Subject: Recall 08V-305 Headlamp Bulb Replacement - Low Beam Bulbs

Service Communication: 2008-004 USA  Designation

Affected Model: 2007-2008 Norge 1200

Illustration:

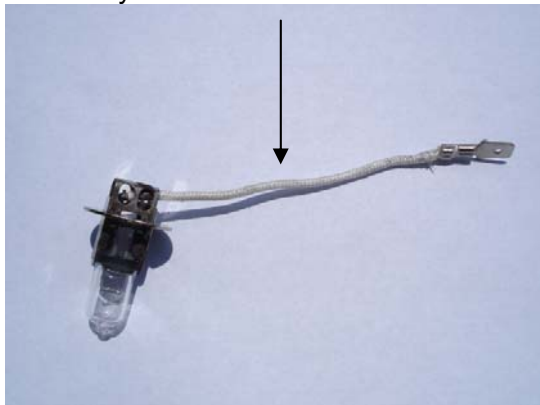
Part Identification: The low beam headlamp bulbs that are subject to this recall do not have a protective sheath over the white wire.

Old style bulb without sheath

New style bulb #981082 with sheath

Correction: Replace the low beam headlamp bulbs with bulbs having a protective sheath over the power wire. VINs included in this recall may be in your dealer stock, with your customers or in bound to your dealership from Moto Guzzi USA inventory. Please update all bikes before being sold and notify your customers to have this recall performed as soon as possible.

Parts Ordering Information: Please order Qty. 2 headlamp bulbs (part # 981082) from the BM ordering system.

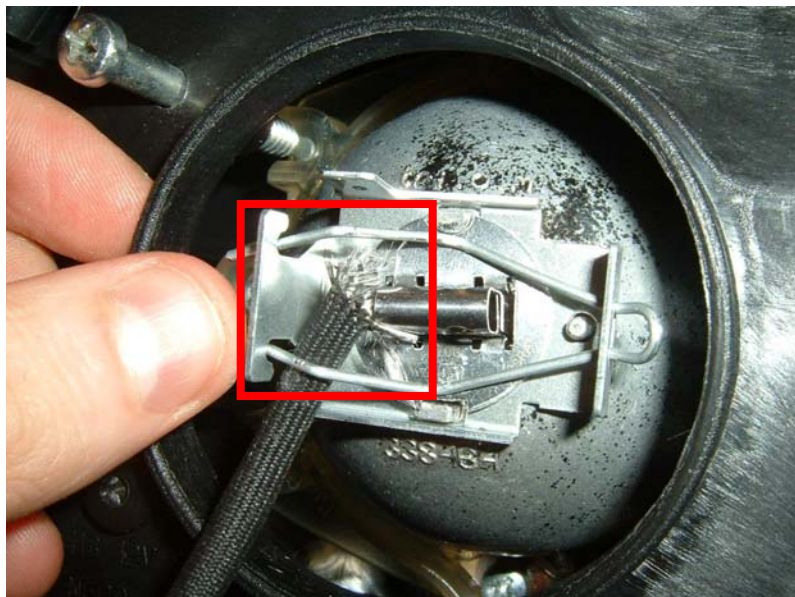
Remove the lamp and replace it with new lamp (code 981082). Align the bulb in the socket as shown, matching the design to the respective bulb cut-out.

When remounting, make sure the cable harness goes under the lock fork as illustrated in the following picture.
